Improving TDECQ Test Definition

(Addressing comments 236, 237, 238, 239, 240, 241, 242, 243)

IEEE 802.3dj Interim Meeting

Figure 86–2—Block diagram for 40GBASE–SR4 and 100GBASE–SR10 transmit/receive paths

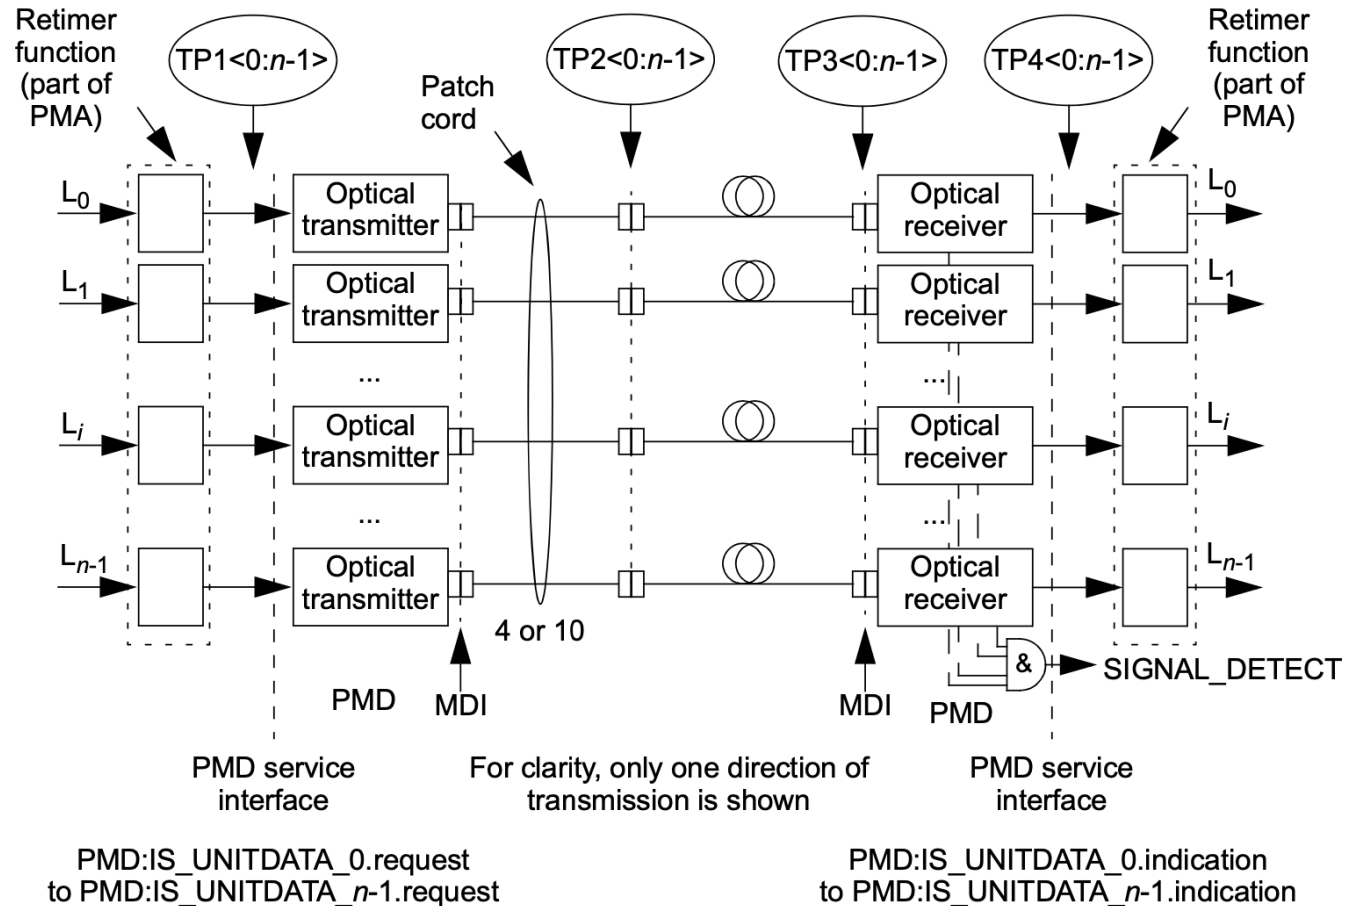
- Clause 86 PMD use nPPI (unretime) electrical interface
 - TP2 is dependent on TP1 input and TP4 dependent on TP3 input
- Below show the usual PMD block diagram where retime function is prior to TP1 and after TP4 given that clause 86 uses PPI interface

□ **Clause 86 as an example provide us clear example that optical PMDs where there is an exposed nPPI or AUI then optical PMDs may need to meet additional requirements**

- There is no contradiction to state in the 802.3dj optical PMD the condition of TDECQ test or receive sensitivity test when there is an exposed AUI!
